**Adapting Option 30 to fit the Cotswolds National Landscape**

**The A417 Missing Link at the Air Balloon**

### **Outline Representation Sept 2021**

**A417 Missing Link at the Air Balloon**  
**Response to**  
**Highways England Supplementary Consultation**  
**13<sup>th</sup> October - 12<sup>th</sup> November 2020**

**Example: 1.2km Tunnel using New Austrian Method** (Maps: Bing, Magic)

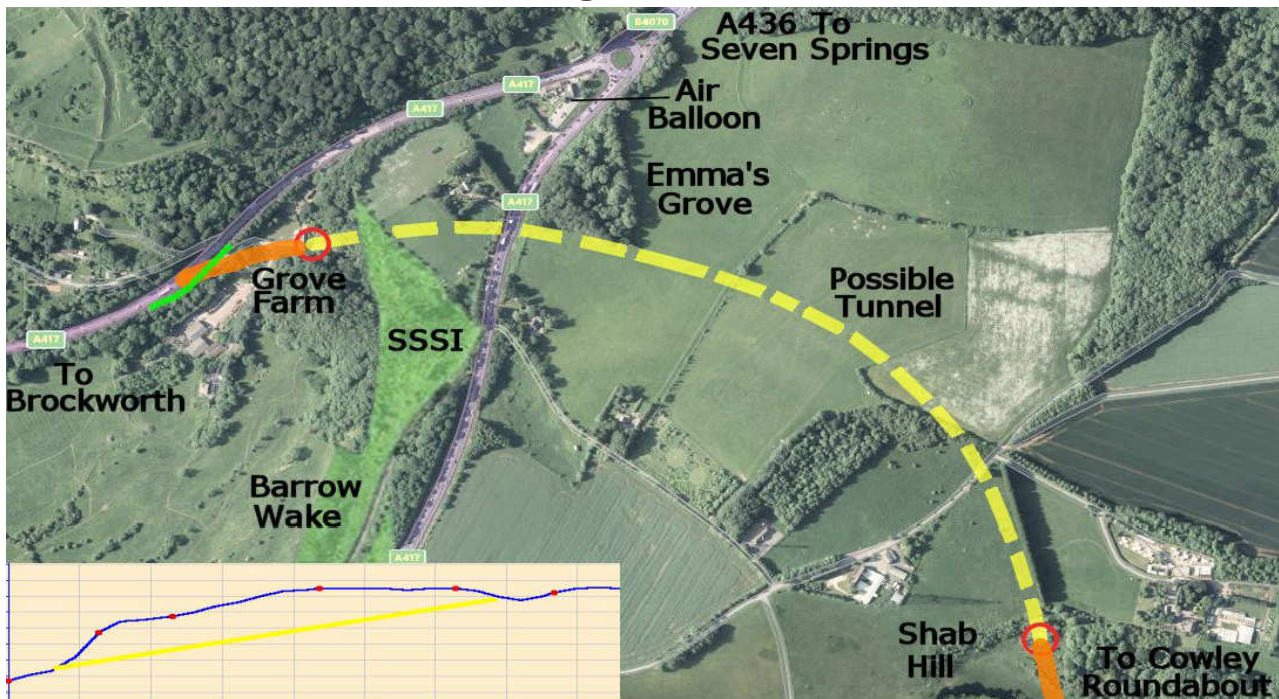
5% Gradient, under Barrow Wake SSSI, avoids Emma's Grove and the Air Balloon

After long and careful consideration of the scheme proposals, it appears that the very special environment of the Cotswolds AONB between Barrow Wake and the Air Balloon can only be properly retained if the new A417 is put into a tunnel.

Ramblers have put forward various tunnel options during the consultations. A 1.2km tunnel, in yellow above, from the scarp edge at Grove Farm to a valley face at Shab Hill, has a height gain of 60 metres i.e. a gradient of 5% - within the DMRB rules of maximum 6% for a tunnel. (Connecting roads shown orange, down slip green as per Option 3 and simplified Option 30.) The A417 gradient from Brockworth to Grove Farm is retained at 7%, less than the currently planned 8%. Option 3 proposed a 1km tunnel slightly south of the line. Option 30, to the north, could be tunnelled between Emma's Grove and the Air Balloon.

Tunnelling Options should be properly considered.

**2. The change in gradient of the A417 as it climbs the escarpment near Crickley Hill**

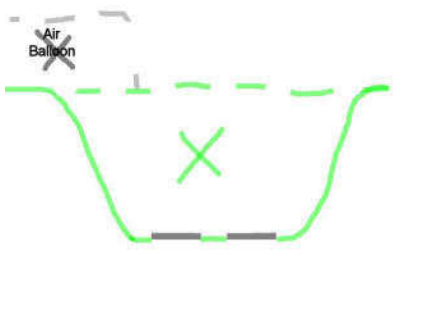
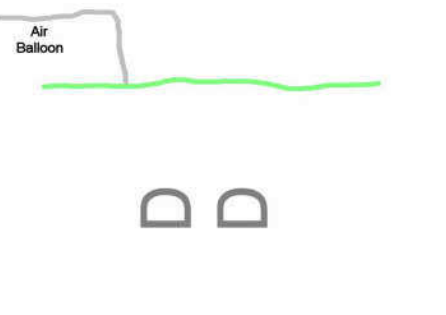
Ramblers oppose the increase in gradient as an overall benefit has not been demonstrated. Ramblers could support if there was demonstrable increase in crossings for paths and retention of the heritage and landscape of the area.

The quoted 10% is a peak gradient near the Air Balloon that would have been avoided by the scheme anyway. The proposed gradient of 8% is greater than the lower slopes of the present A417.

Although a peak gradient of 8% may be useful in places it should only be used where it might be necessary and not where it could detract from the landscape. For example raising the road onto an embankment at tree height could lead to visual and noise intrusion. An embankment could offer under-passes rather than over-bridges for footpaths, bridleways and tracks.

There is a step change in height of the landscape east of Grove Farm. A 1km tunnel between there and Shab Hill would have a maximum gradient of 6% and may not need a crawler lane.

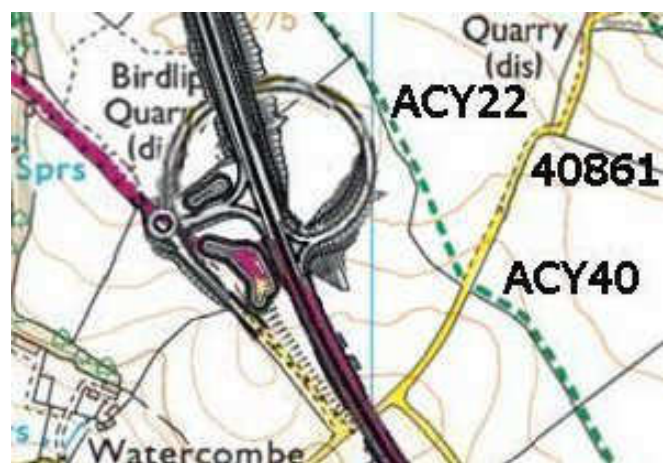
- mixes a low traffic walking cycling and riding route with that of traffic from the A417 to Nettleton and beyond. It also diverts footpath ACY22
- converts ACY22 to a Restricted Byway - loss of a field footpath. Many walkers would not consider change of use of a footpath, for other uses, as a benefit.

As described in the proposal, the aims of this junction seem to be to

Ramblers could support if

- ACY22 was retained as a footpath to link with footpath ACY40.
- a redesign of the junction if it provided a separate bridge or underpass for A417 linking traffic perhaps using the old Quarry.

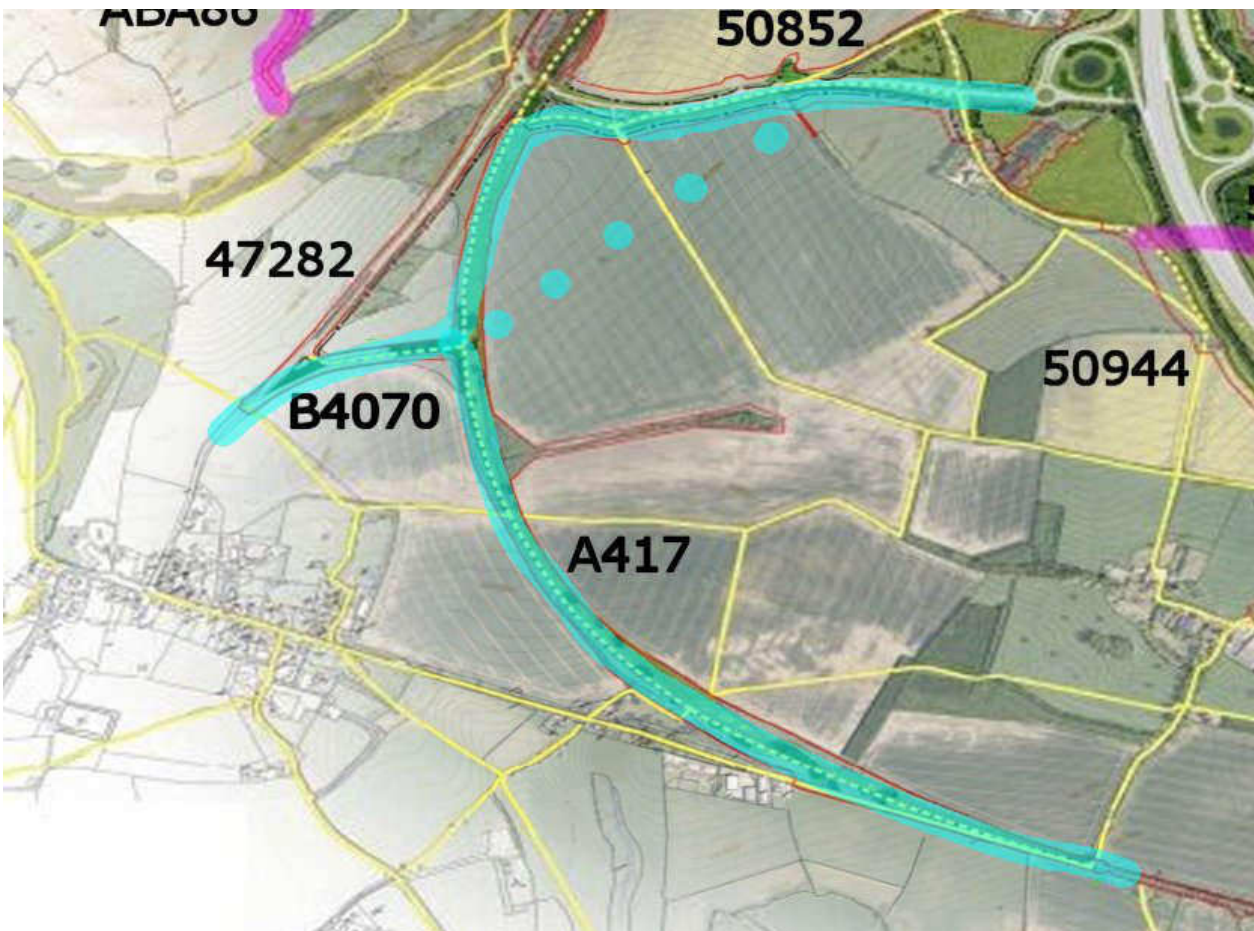
Ramblers Oppose the the new link road to Birdlip taking this quiet section of old road used for Walking Cycling and Riding. Ramblers could support another route for the link road away from this edge of the Escarpment.

The whole length of the existing road 42782 into Barrow Wake car park has good views from the edge of the escarpment. There are often 20-30 vehicles parked up either taking a break or for longer term parking for walks etc. If the proposal to use the road for the Birdlip link was to progress, these vehicles could fill up the Barrow Wake car park viewpoint.

These proposals take the Birdlip link road through the Barrow Wake underpass and install a roundabout at the view point car park entrance. The quiet walking and cycling road 50852 to Shab Hill is to be repurposed as the link between the new A417 and Birdlip village.

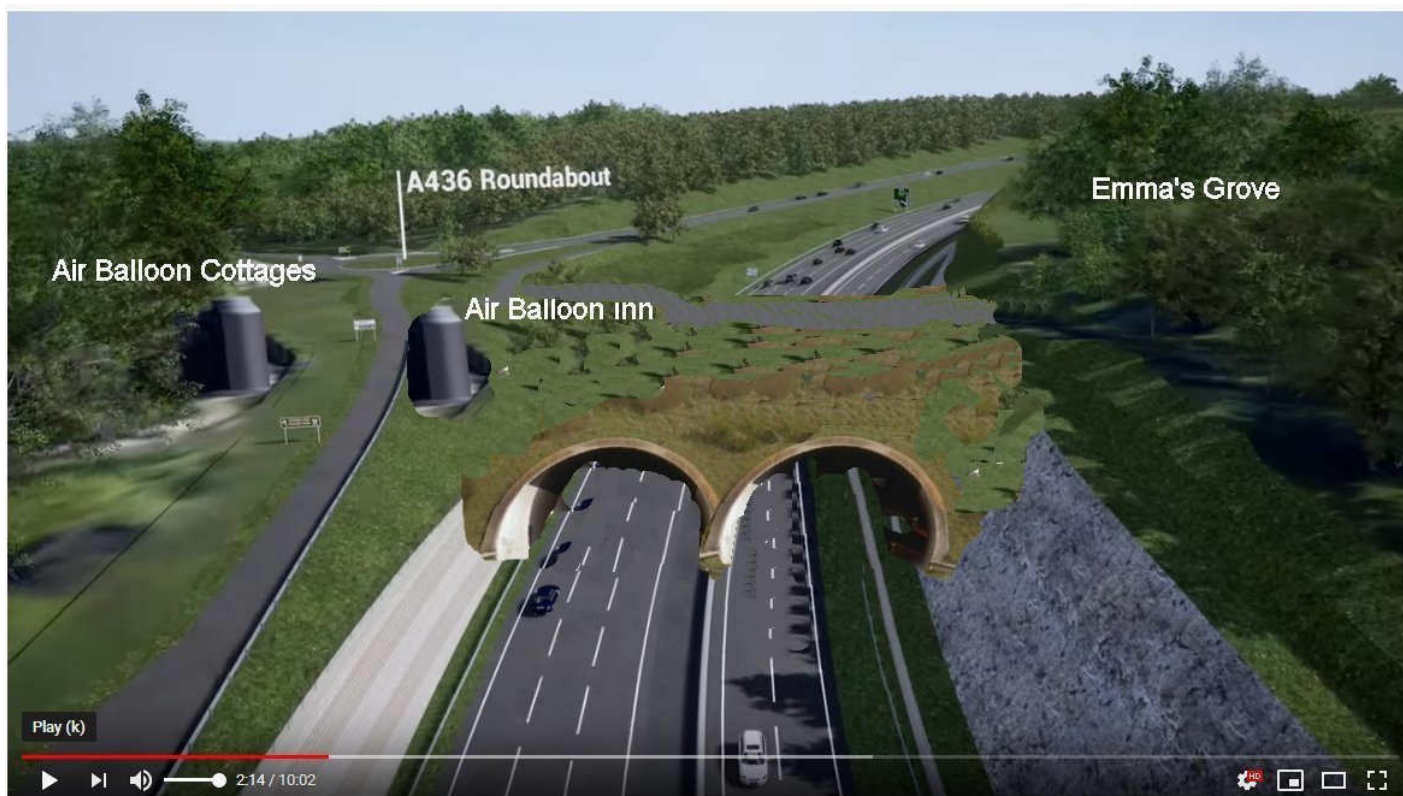
Below photoshop sketch image of the Air Balloon Inn retained next to a green flanked bridge over the new A417. Just behind the Inn (these videos use silos for buildings) is the road across past Emma's Grove which currently heads towards Birdlip and Cowley Roundabout. This is shown as alternative 1 in Highways England plans. Alternative 2 incorporates the new A436 link road ahead to reach Shab Hill junction and either head to Birdlip or drop down to the A417 dual carriageway.

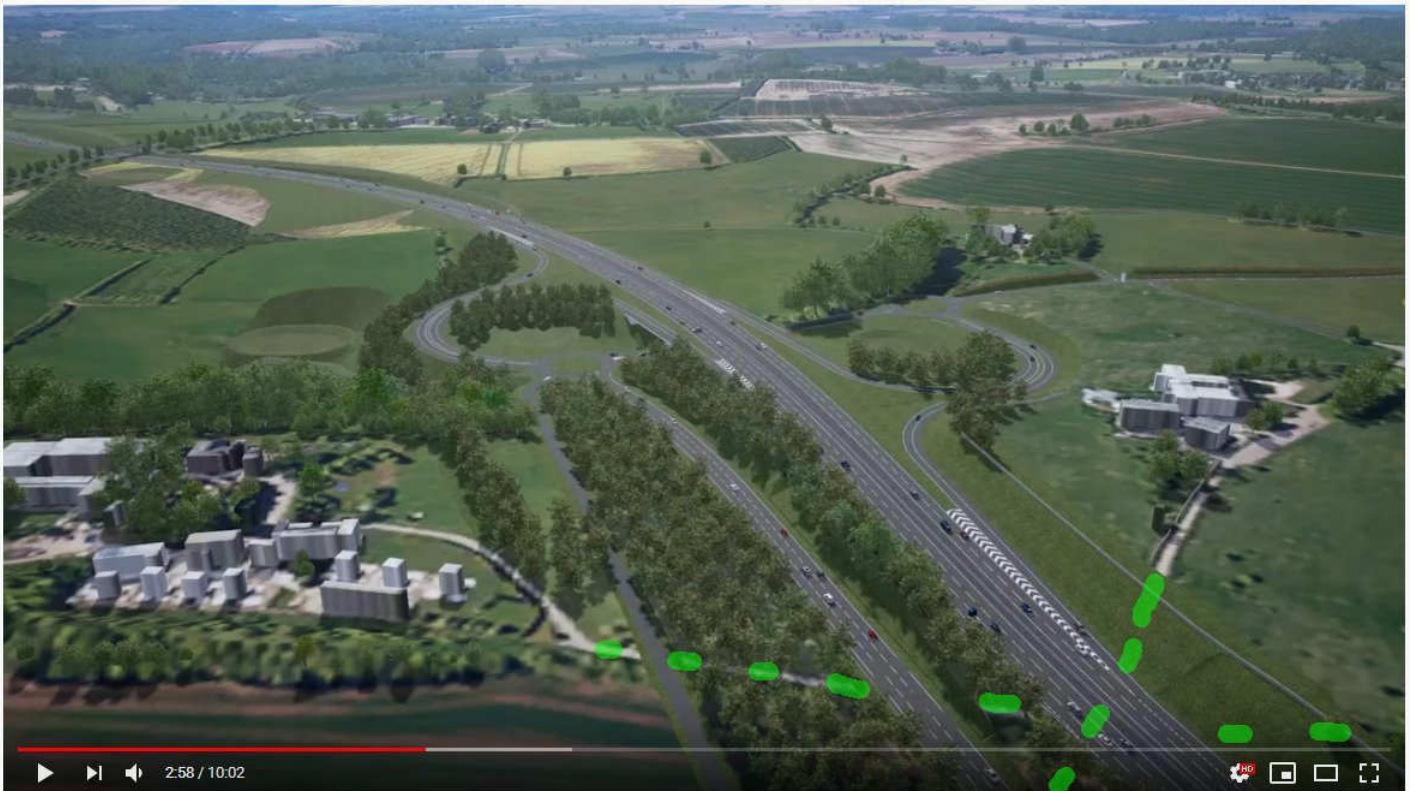
An updated image shows the Gloucestershire Way also passing the Air Balloon before heading away through Emma's Grove and the Neolithic round barrows. The Cotswold Way passes the Air Balloon but continues to Barrow Wake.

A 50metre Wildlife Corridor over the current road left could link Crickley Hill SSSI over the new dual carriageway and on to the Barrow Wake SSSI if they didn't mind being next to the Air Balloon site.

SECTION AT SHAB HILL

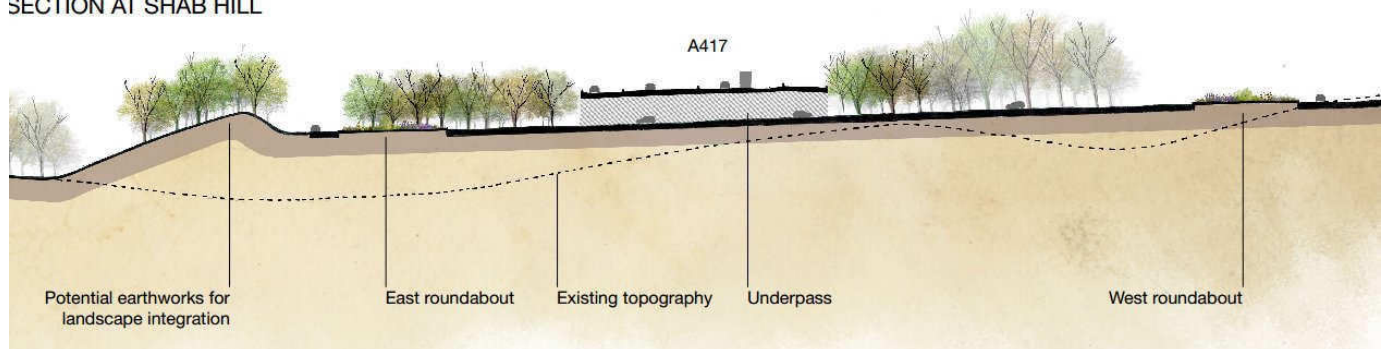
The proposed Shab Hill Junction is upside down – traffic has to accelerate uphill to join the new A417. It's also at a landscape high point. With the new A417 taken on a flyover, its elevation could give noise concerns across the countryside.  
 Surely if the junction is to be located here, it should be inverted with the A417 in a cutting underneath the link road.

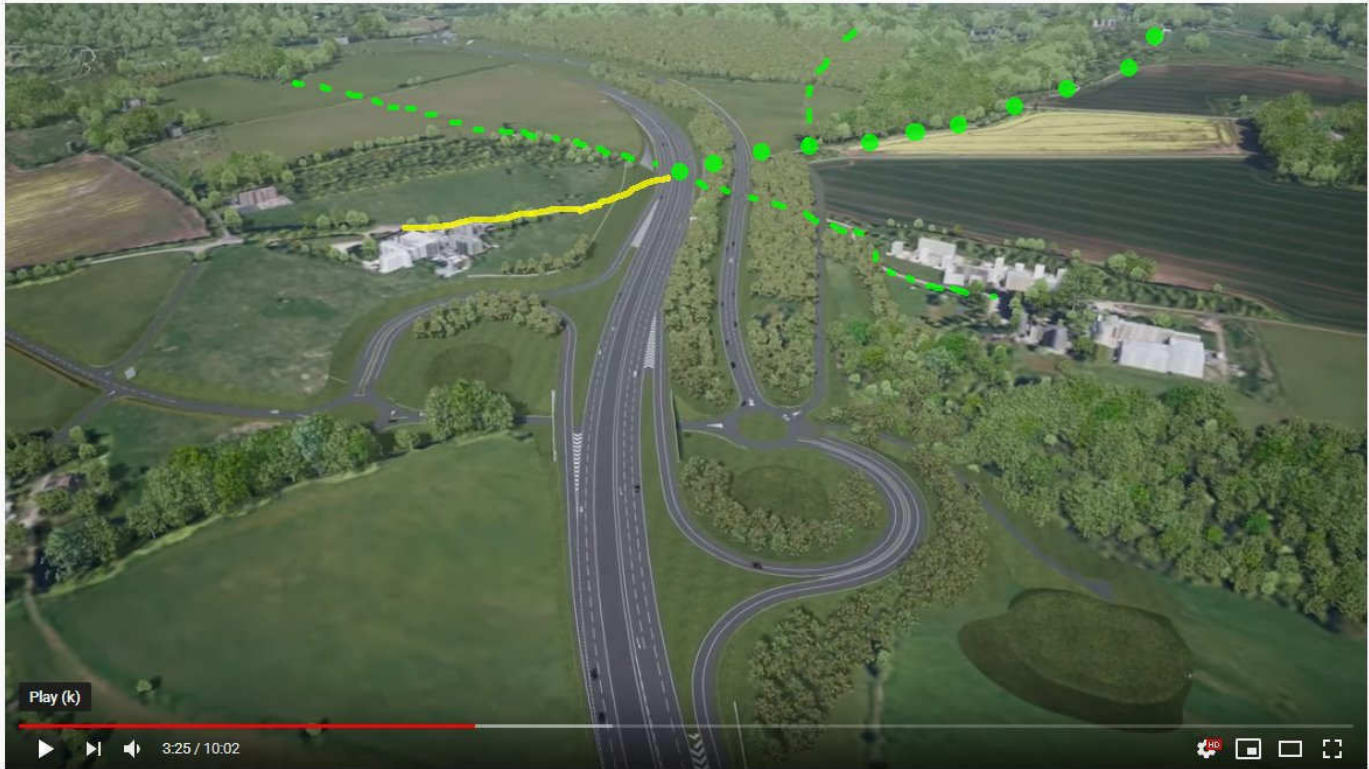
Another view of the Shab Hill junction this time looking north and showing where there is a 'crossroads' a number of paths bridleways tracks etc. Footpath ACY3 and ACO16. ORPA 50852 (dots) with Footpath ACO15 heading north. The yellow lane passes through Birdlip radio station.

Although a crossing point here seems obvious, there is currently no plan for a bridge. Walkers cyclists and riders are diverted elsewhere.

**Concrete Bridge above**

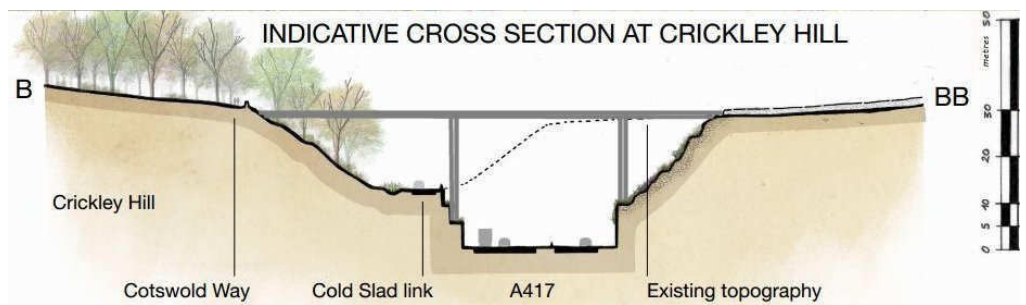
This image illustrates the height of the proposed concrete bridge. A layer of vegetation on the top allows it to be referred to as a Green Bridge.

**Green Flanked Bridge**

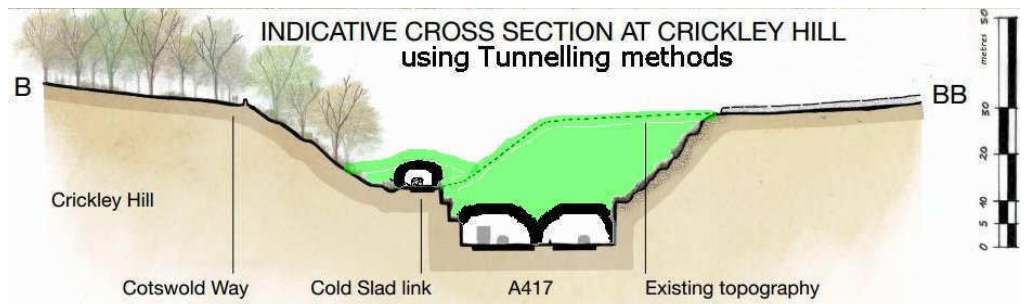
Green 'flanked' bridges could be installed instead. A standard inverted U bridge as used in the Dorset AONB could cover the minor Cold Slad link road (the current A417). A tunnelling method similar to Hindhead could be used for the new A417 to retain the existing topography.

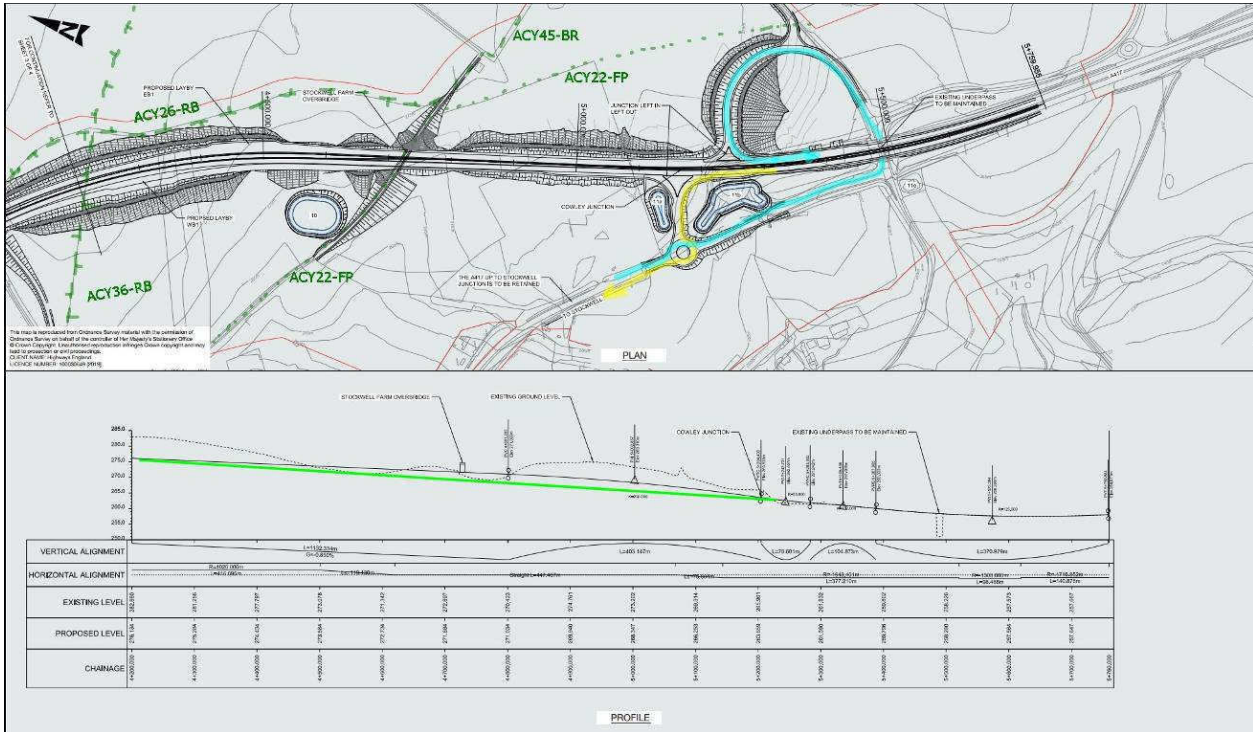
The map image right overlays option 30 onto an OS map. An avenue of lime trees heads north east from Stockwell Farm either side of the current lane. Highways England proposal is to break a small road through the lime trees, build a bridge in parallel with the current lane, then demolish some of the rest of the avenue with the new dual carriageway. The previous flythrough video image shows new trees planted on the flanks of the new bridge i.e. not inline with current.

An option here would be to build the new bridge on line within the lime trees where possible and replant new or reuse trees in line with the present ones.

**Possible alternative route east of Stockwell Farm**

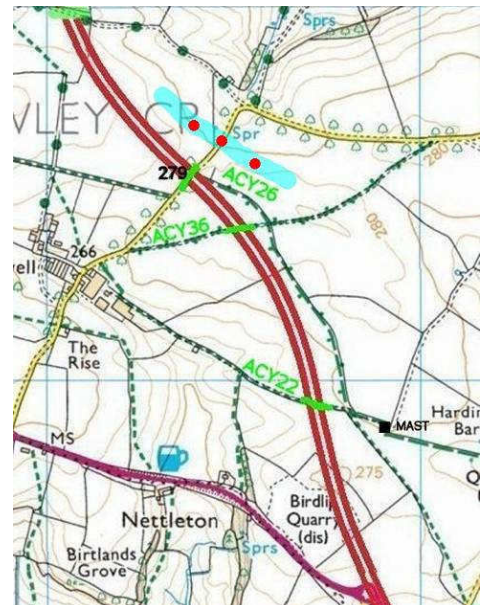
Some of the proposed Option 30 route is elevated, for example on the west side of ACY26 at grid ref. SO 944-145 Page 3 of this document discusses dropping the route deeper into the landscape to reduce the impact on the avenue of lime trees. A natural dip in the landscape has been noticed nearby (SO 944-146) which could offer an alternative alignment for the road to the east of ACY26 (shown in cyan with red dots below right), avoiding the lime trees and heading south towards the west of MAST. Much of ACY26 follows an ancient hedgerow. A technical review has been requested via the Environment, Heritage, Landscape Technical Working Group to evaluate visual & noise impact of this alternative route compared to the current proposal.

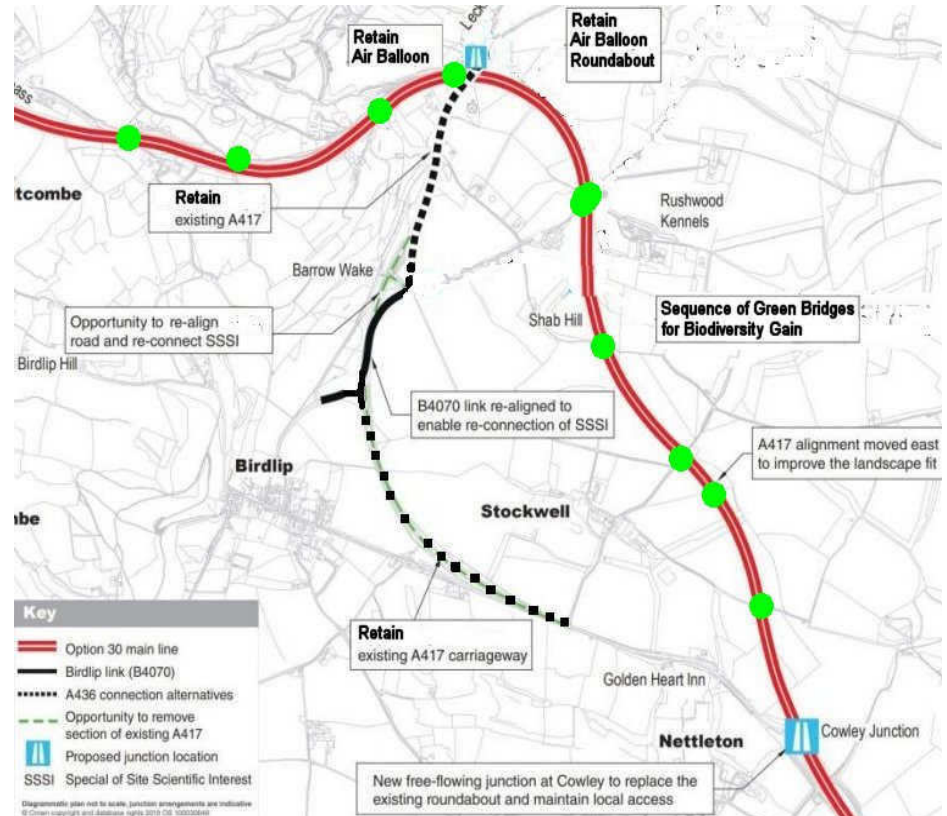
Save for a minor realignment of the current road around the Barrow Wake SSSI everything else stays the same but with all the through-traffic removed.

If funding arrangements could be re-assessed there is still the opportunity to replace all the deep cutting with a 1km tunnel.
